Verification Report

McAlear & Rushe

101 Charles Street

AREA SURVEYED: East Toe Detail - South Toe Detail

ADDITIONAL PHOTOGRAPHS

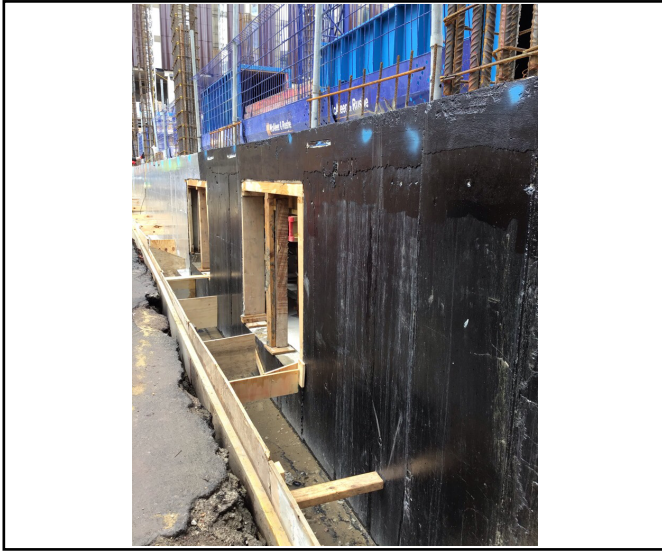
GR SAM patched applied to

hole
